Working Party on Passive Safety

Seventy-third session
 Geneva, 15–19 May 2023

Report of the Working Party on Passive Safety on its seventy-third session

"Annex 5 – Appendix 2

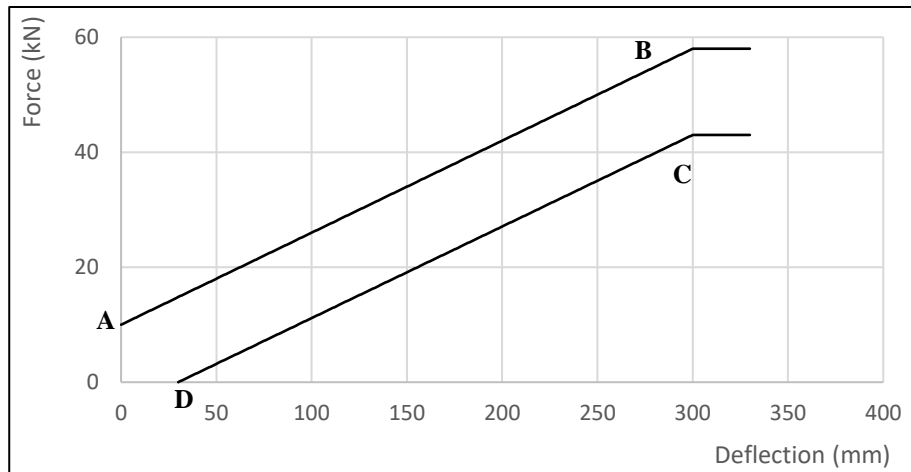
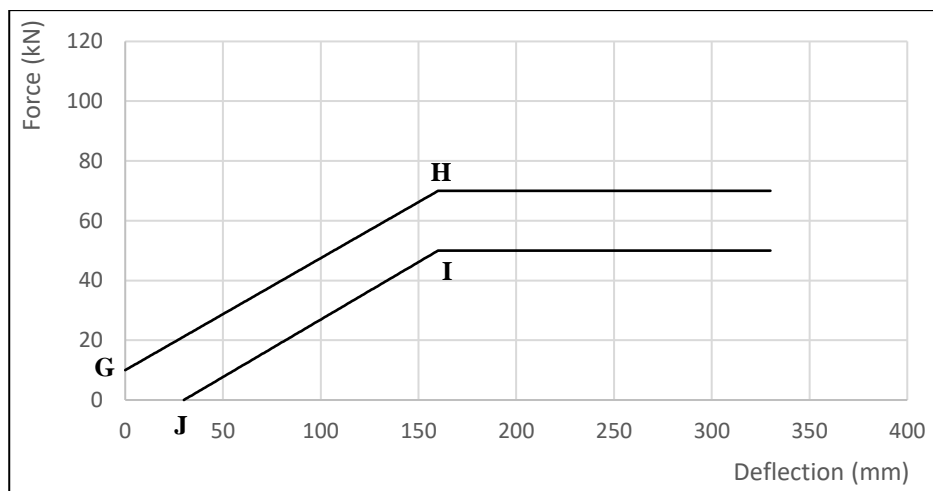
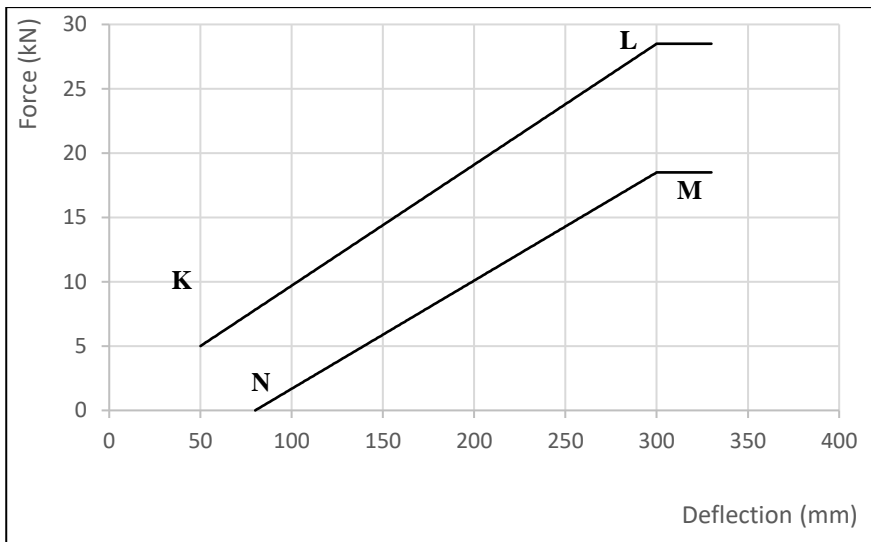
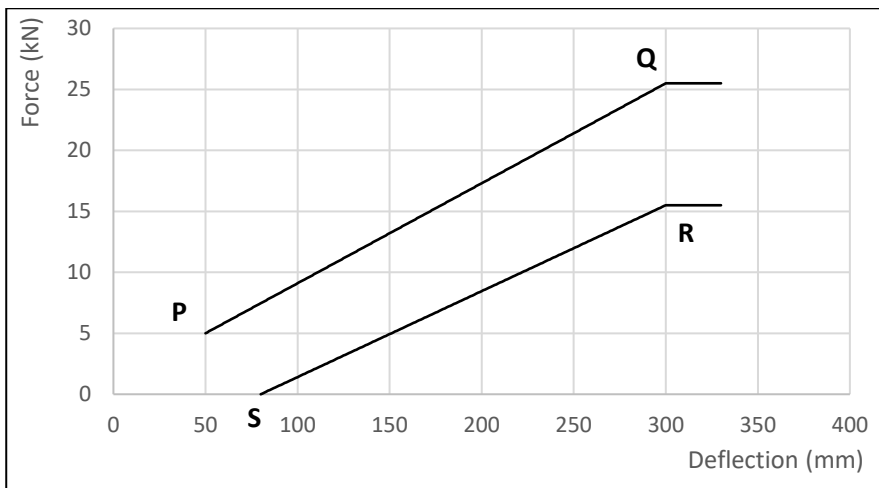
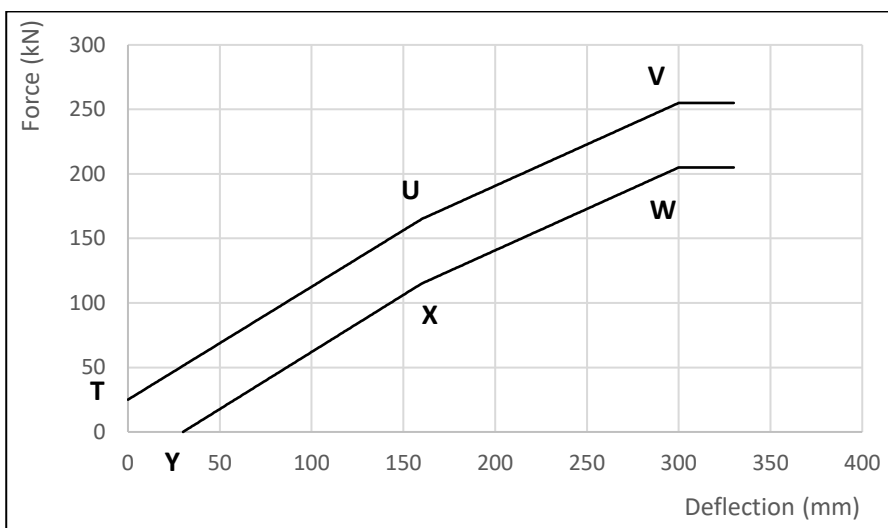
24. The expert from France introduced GRSP-73-44 and GRSP-73-45, to amend respectively the 04 and 05 series of amendments, to clarify the figures of Annex 5, Appendix 2 and to reintroduce legends which had been removed from the 02 Series of Amendments to the UN Regulation. GRSP adopted both proposals, as reproduced in annex VI, and requested the secretariat to submit GRSP-73-44 as draft Supplement 3 to the 04 Series of amendments, and GRSP-73-45 as draft Supplement 4 to the 05 Series of Amendments to UN Regulation No. 95 for consideration and vote at the November 2023 sessions of WP.29 and AC.1.

Figure 3 (j)
Test 1

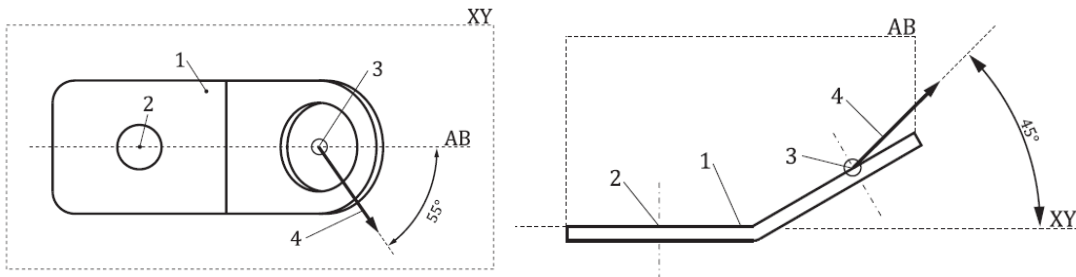
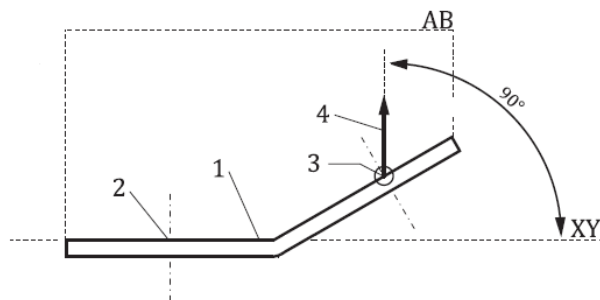
Two tests **shall be** performed; See figure 3 (j) and 3 (k)

(a) the force shall be applied ..., measured in plane AB; **rotation around the anchorage point to vehicle (2) shall be prevented.**
